Supplemental Information for Equipment Report -- 20E-057

**4) Describe what distinguishes the remedy component from the recalled component.
(adds chart and picture to description)**

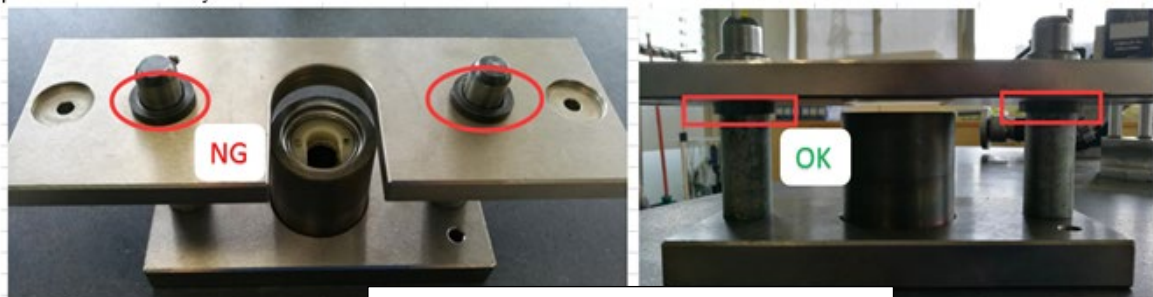
The operator mistakenly reverse crimping fixture during production, so the tool can't limit the fixture's position. The operator didn't increase pressure on crimping fixture for 2 sec. according to SOP so the crimping is not processed correctly.

WHY1: Crimping machine did not put enough pressure on casting to secure seal properly.

WHY2: Process operator reversed the crimping fixture which caused the tool to limit the crimping angle and pressure.

WHY3: The SOP was not followed correctly and controls were not adjusted to include two seconds of applied pressure.

WHY4: The sum of tolerances between the casting and plastic seal, plus the lack of controls to lock the plastic seal during assembly can lead to improper crimping, allowing the seal to move.

WHY5: The master cylinder design does not consider an error proofing solution to secure the seal regardless of assembly and operator mistakes.

Master cylinder was re-designed by manufacturer Yusin to include a C-clip which will secure the seal. MPA has validated C-clip redesign made by manufacturer Yusin's with push (destructive) and durability test.
